INTERNATIONAL STANDARD

AMENDMENT 1 AMENDEMENT 1

Medical electrical equipment – Part 1: General requirements for basic safety and essential performance

Figure 17 – Circuit de mesure pour le COURANT DE FUITE PATIENT de la ou des CONNEXION(S) PATIENT à la terre, provoqué par une tension externe sur une ENTREE/SORTIE DE SIGNAL (voir 8.7.4.7 c))

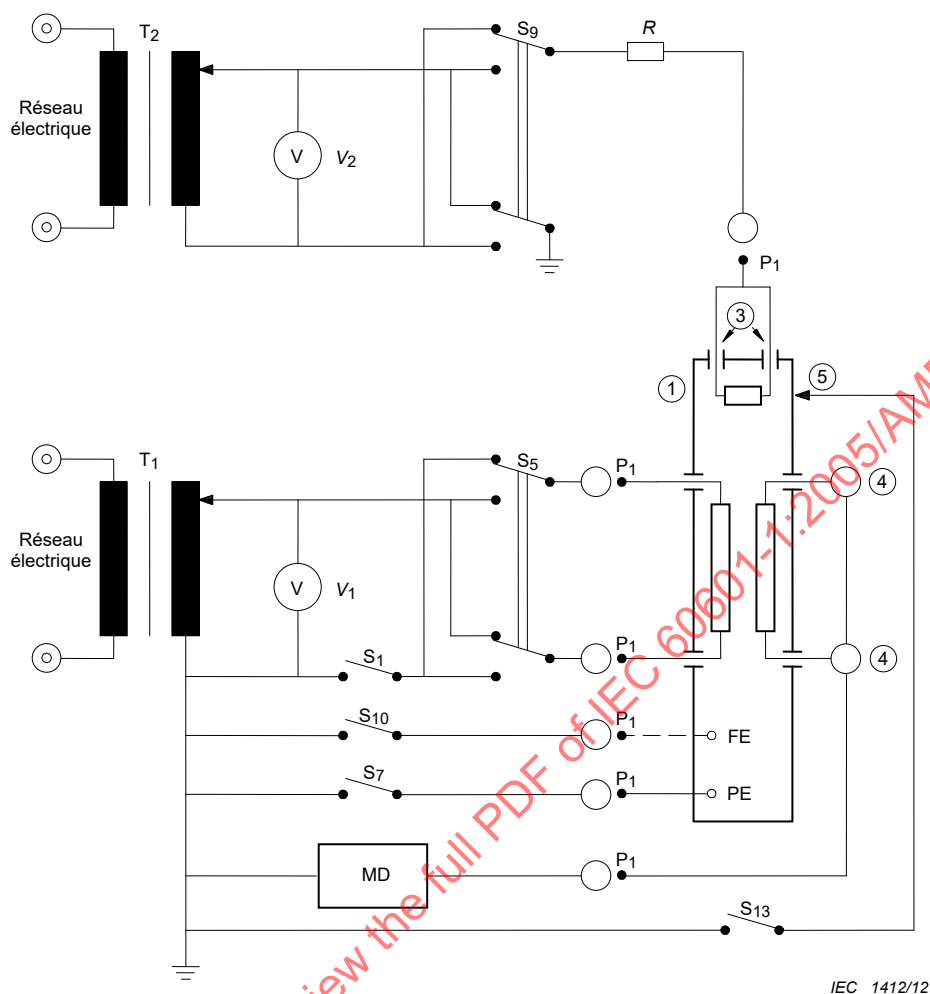
Remplacer la Figure 17 existante par la suivante:

Figure 18 – Circuit de mesure pour le COURANT DE FUITE PATIENT de la ou des CONNEXION(S) PATIENT à la terre provoqué par une tension externe sur une PARTIE ACCESSIBLE métallique qui n'est pas PROTEGEE PAR MISE A LA TERRE (voir 8.7.4.7 d))

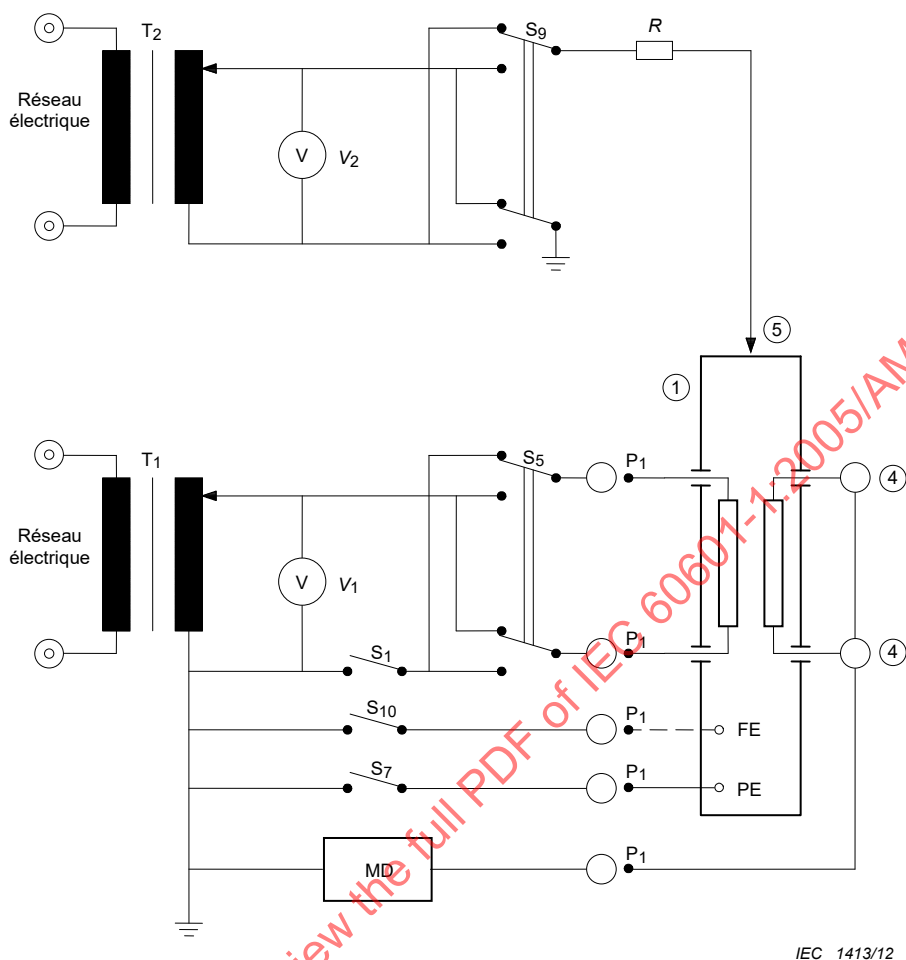
Remplacer la Figure 18 existante par la suivante:
